ADDENDUM No. 3

RFP No. 25-57

SOUTH MAPLE PARK AND DEXTER PARK IMPROVEMENTS

HMA COURT PAVEMENT DETAIL (ALTERNATE)
NOT TO SCALE

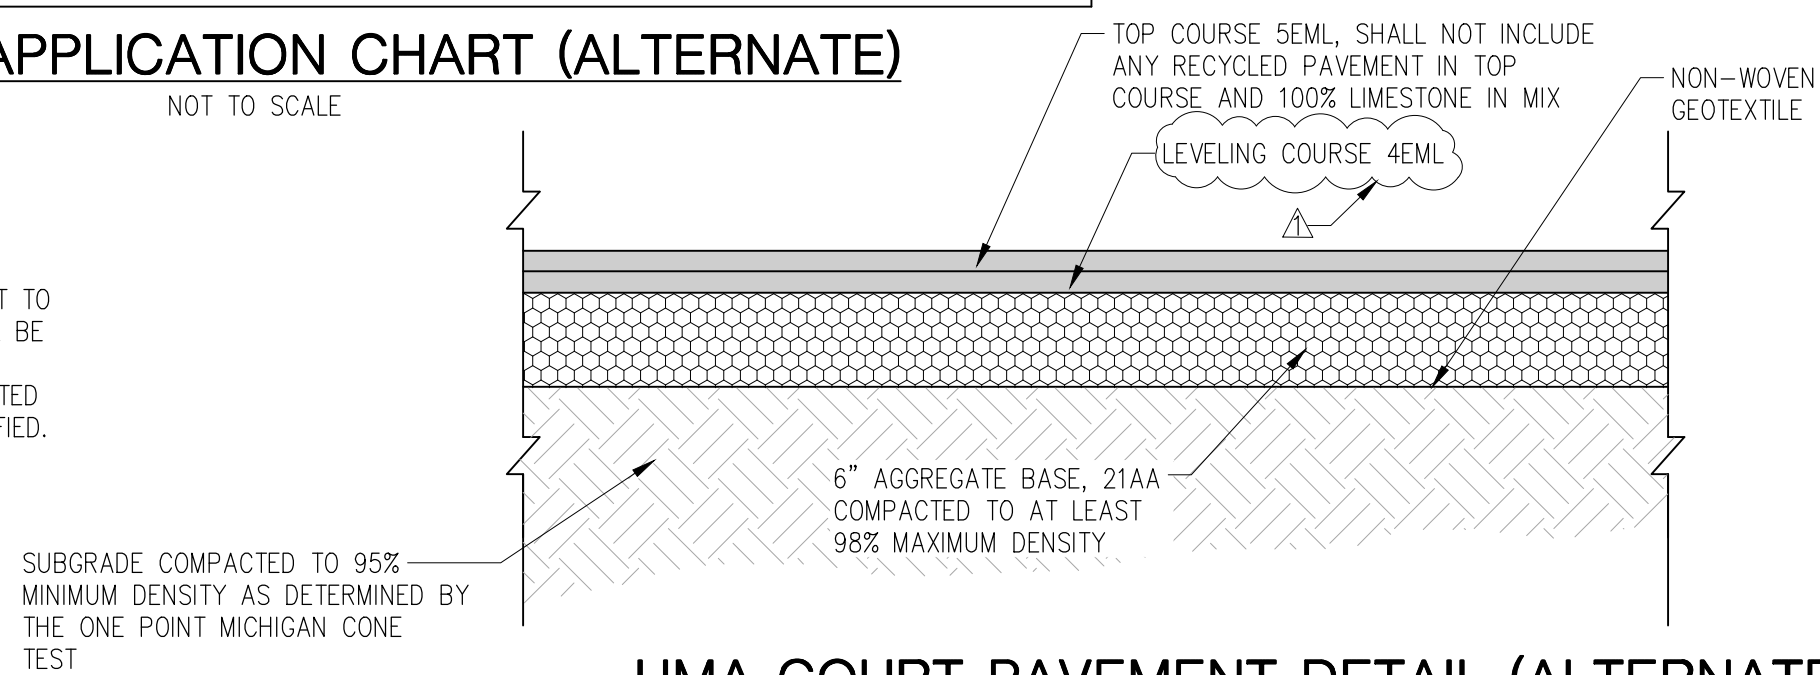
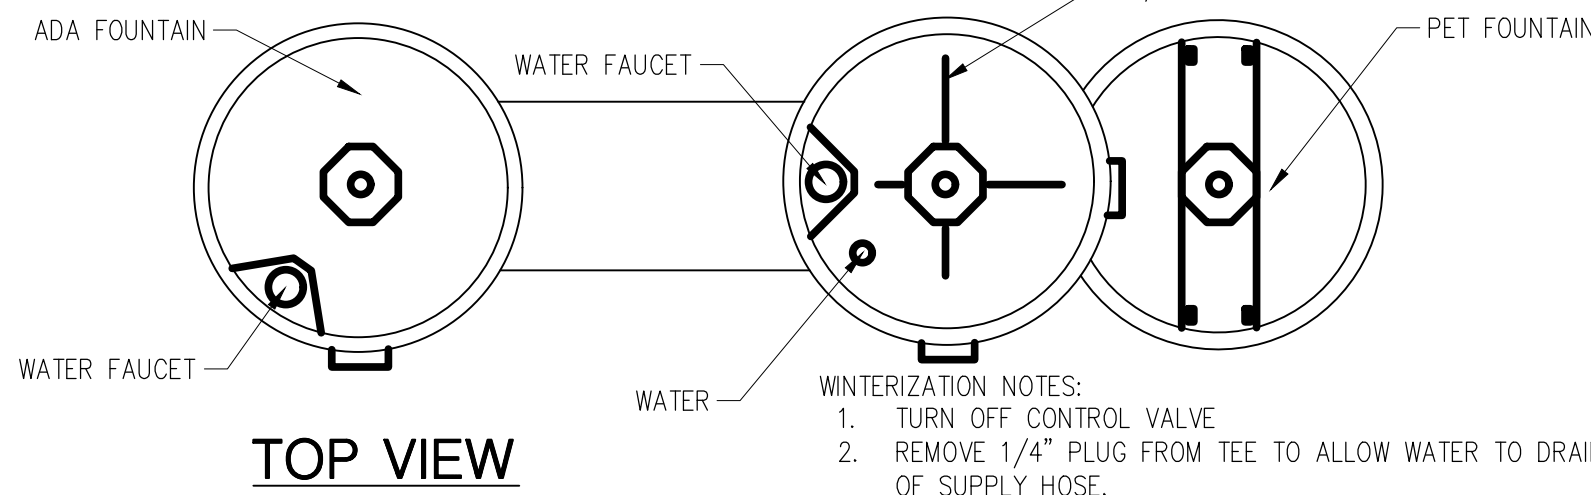
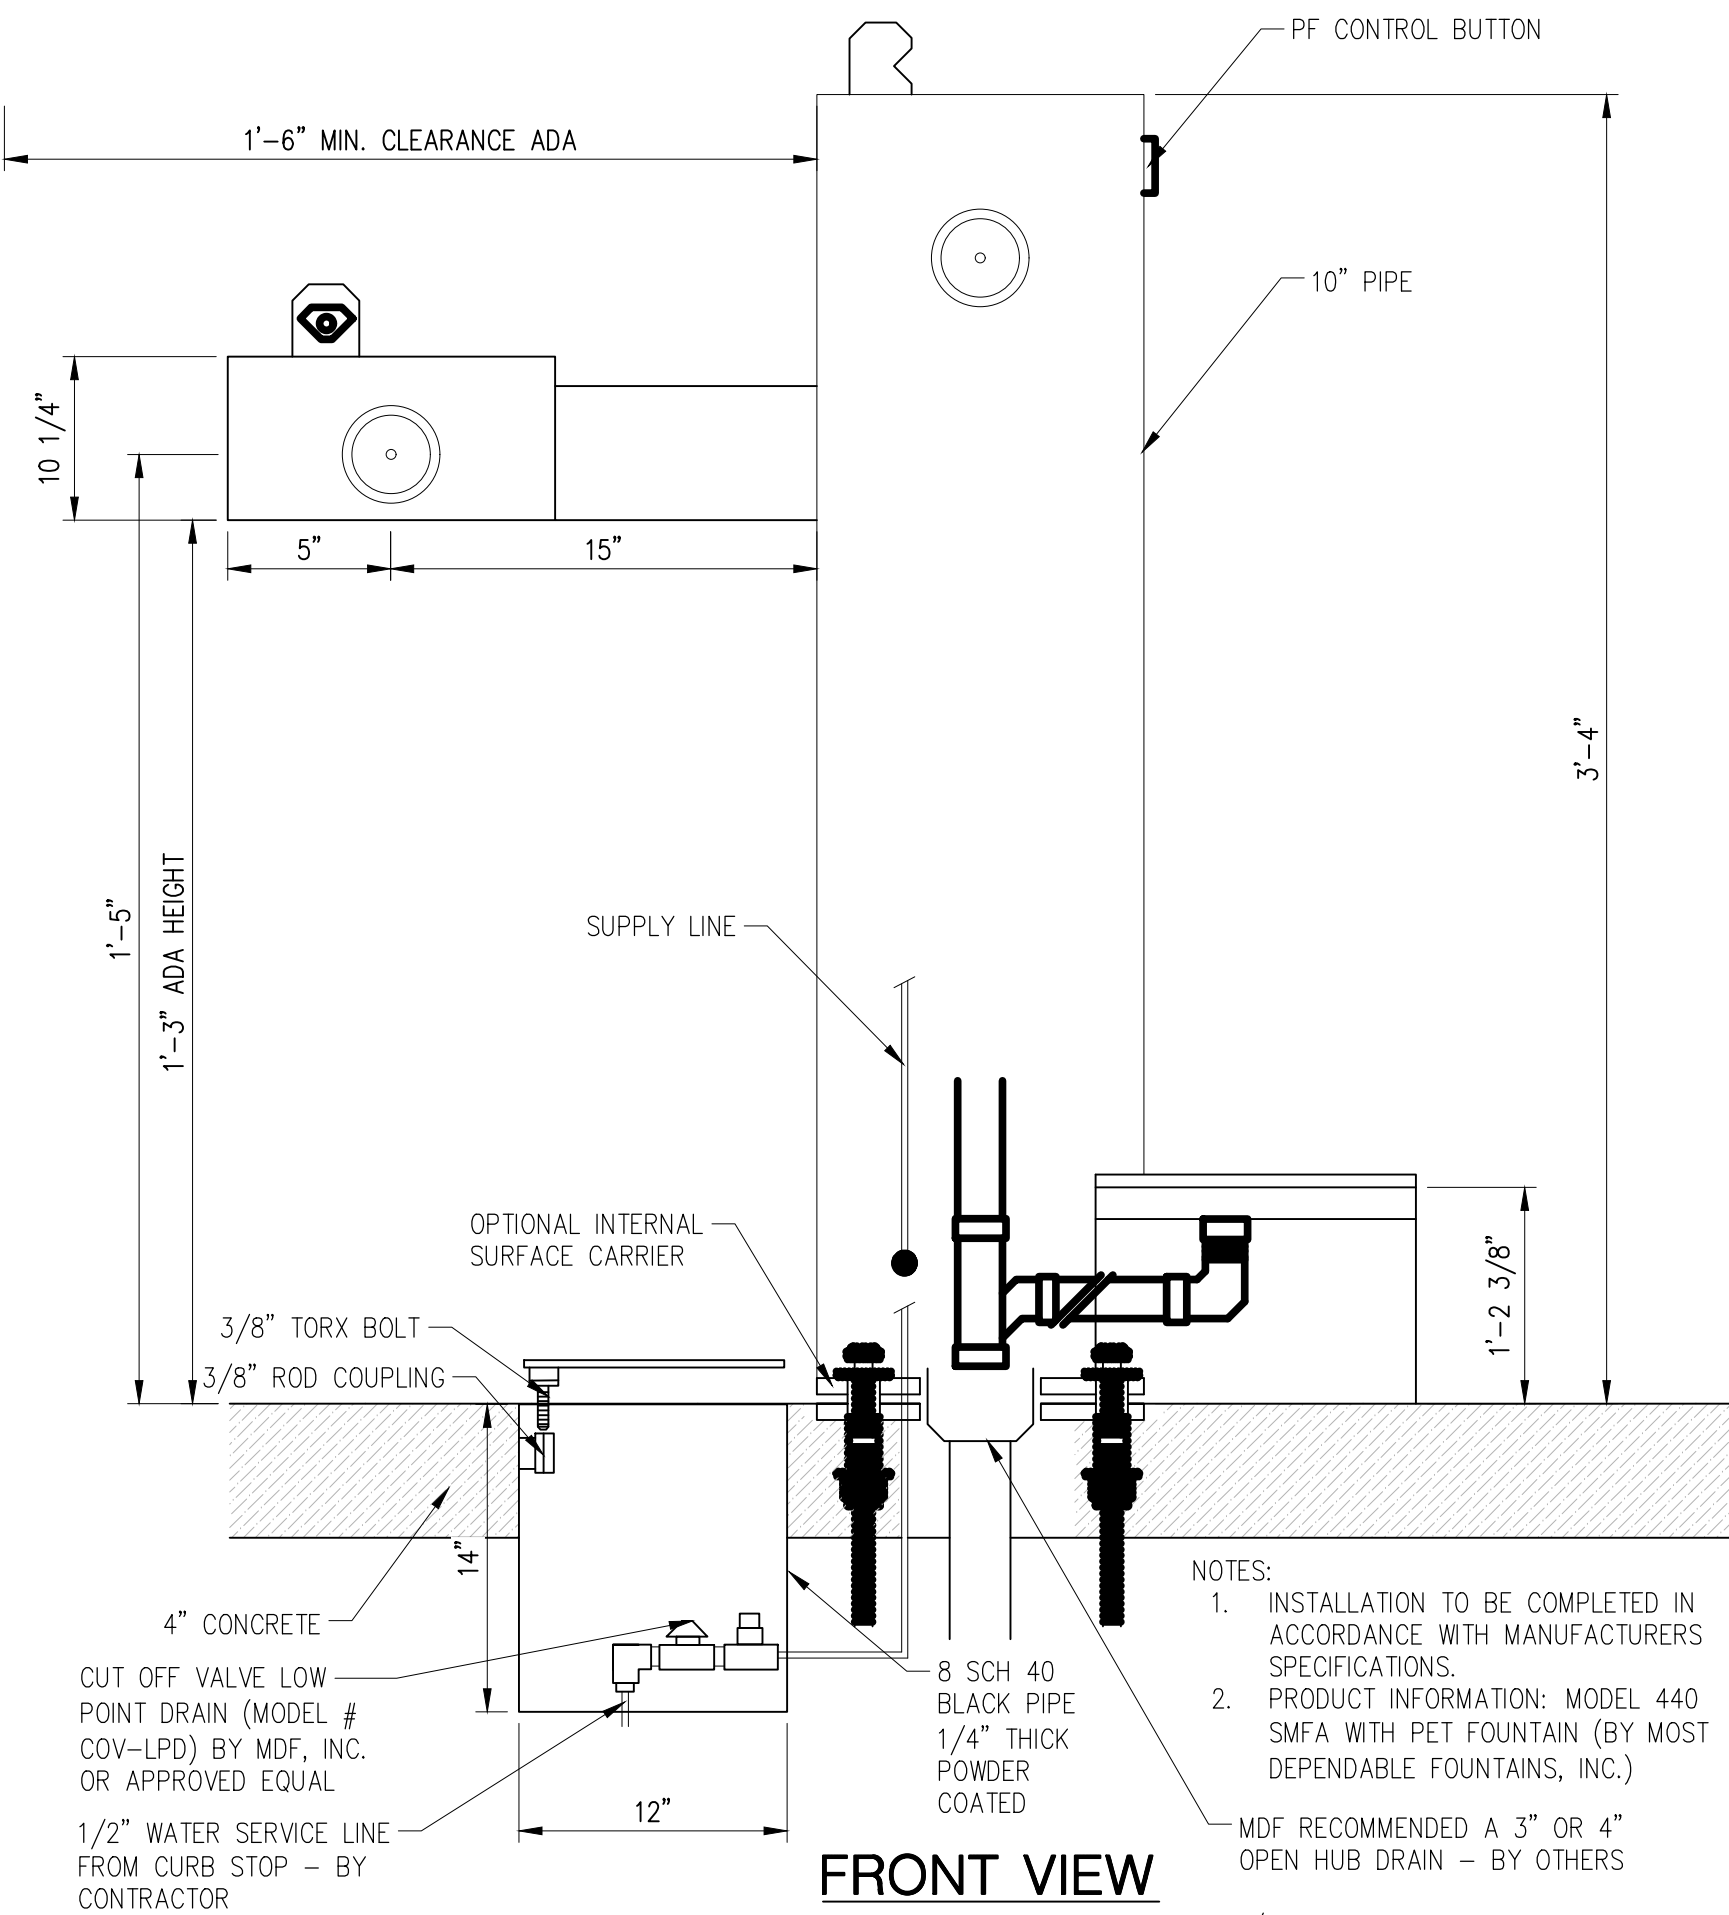
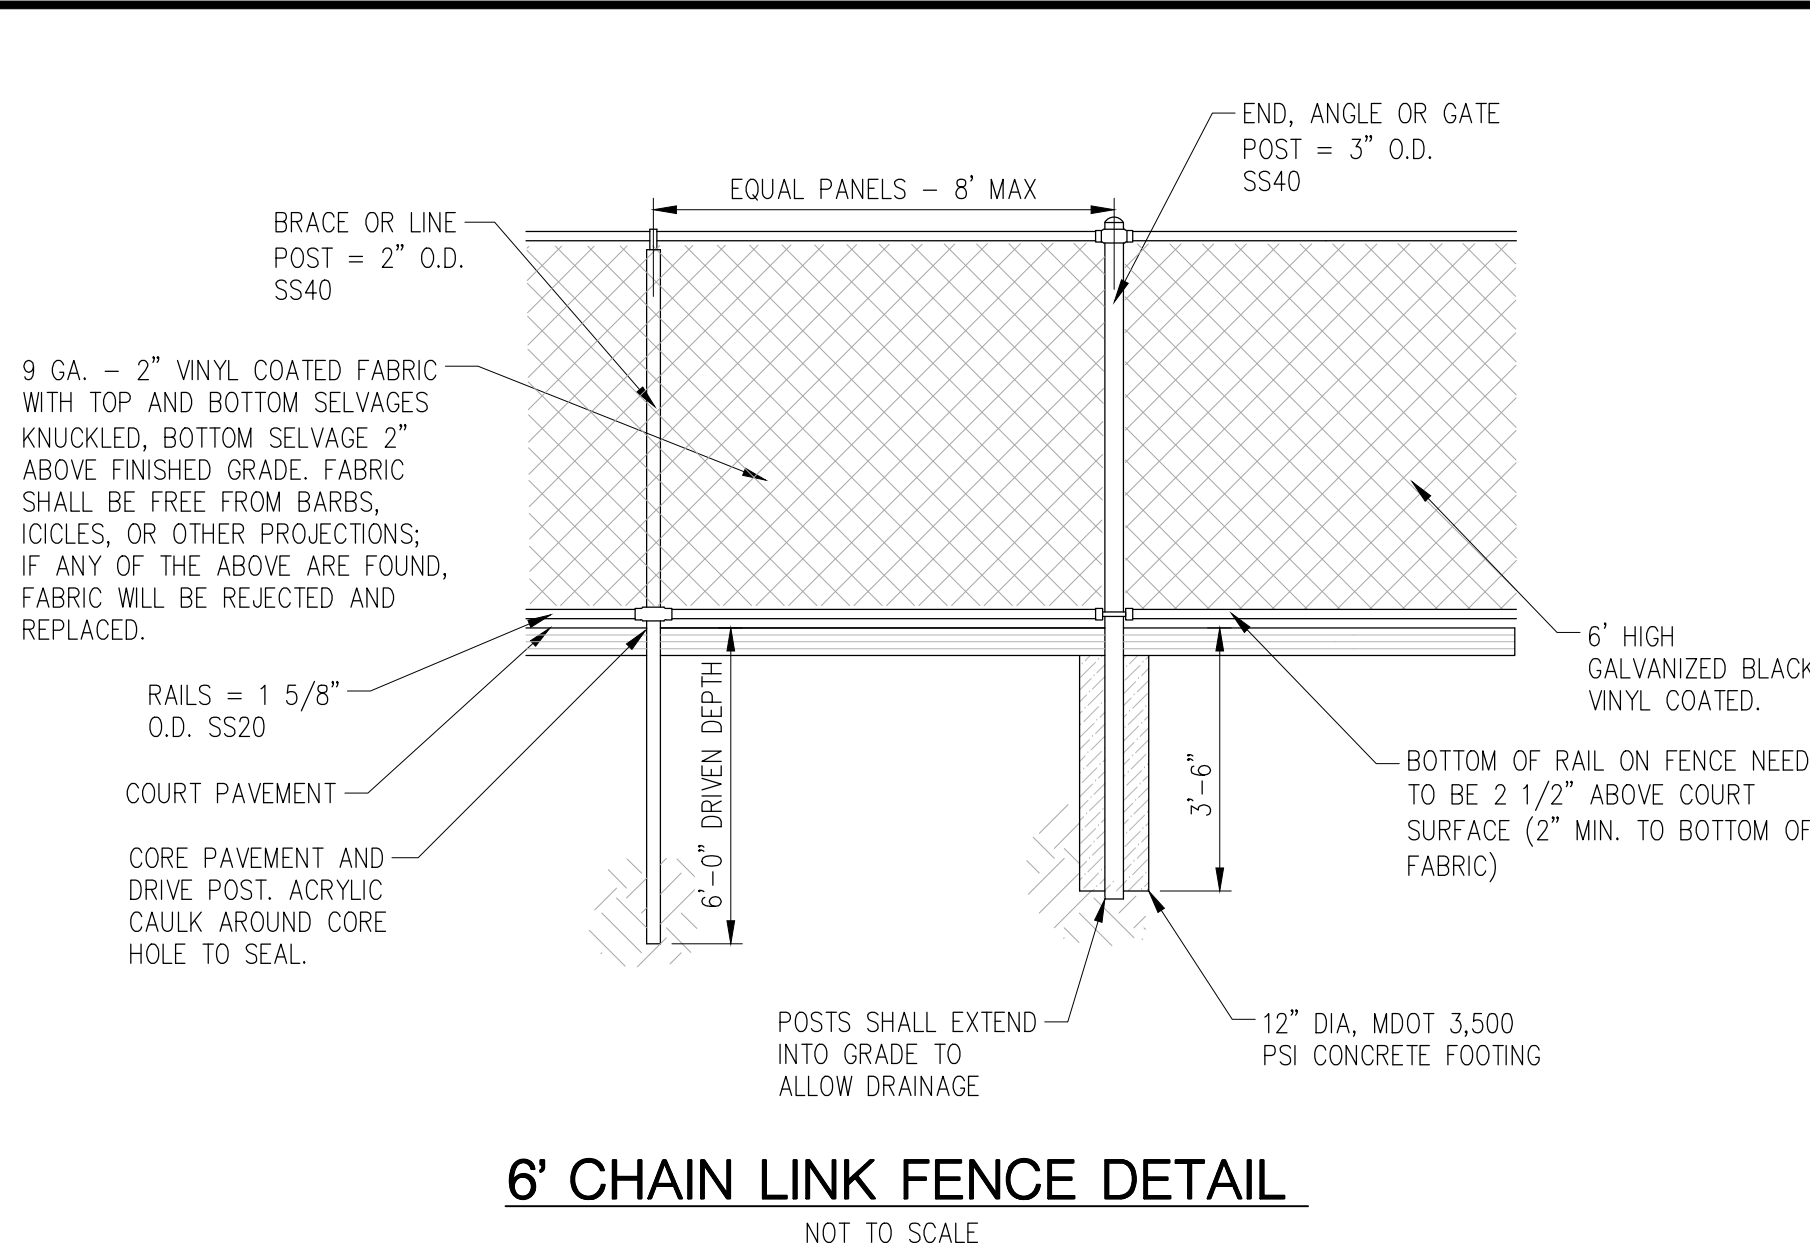
Question 1: Can clarification be provided on the HMA court detail for Dexter Park?

Answer 1: Yes, the Schedule of Pricing / Cost and Detail Sheet 5 have been replaced in its entirety with the corrected information.

HMA ROAD PATCH REPLACEMENT
NOT TO SCALE

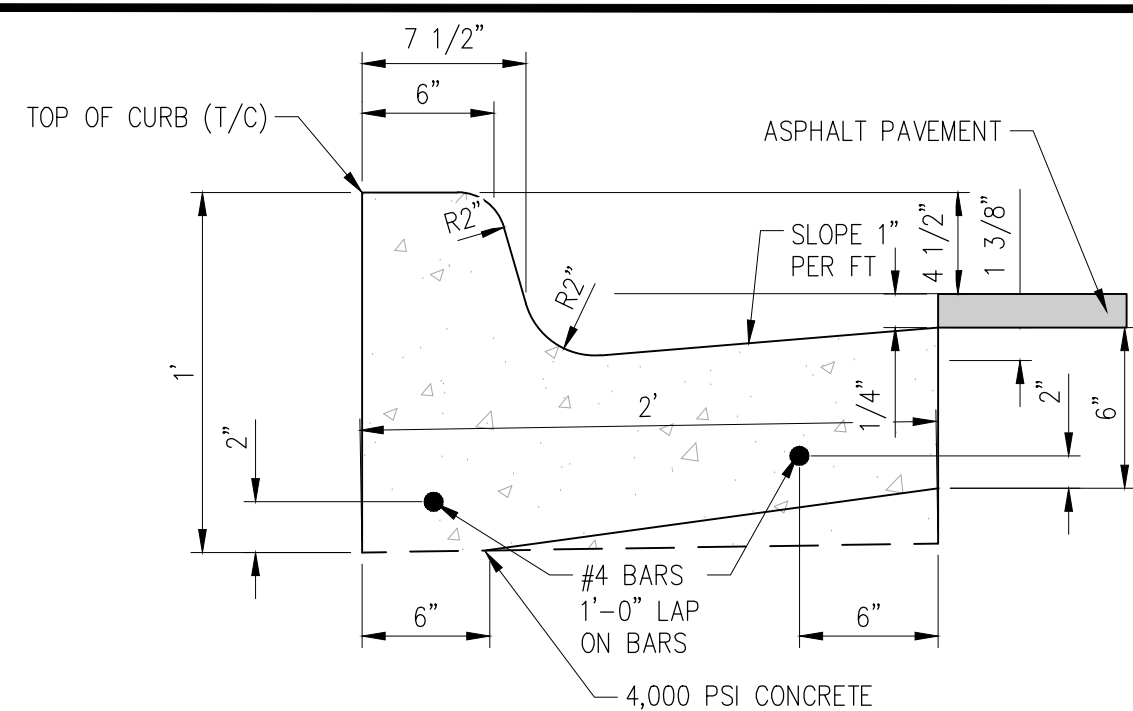
Question 2: Can clarification be provided on quantities for the HMA road patch replacement detail for Dexter Park?

Answer 2: Yes, the Schedule of Pricing / Cost and Detail Sheet 6 have been replaced in its entirety with the corrected information.
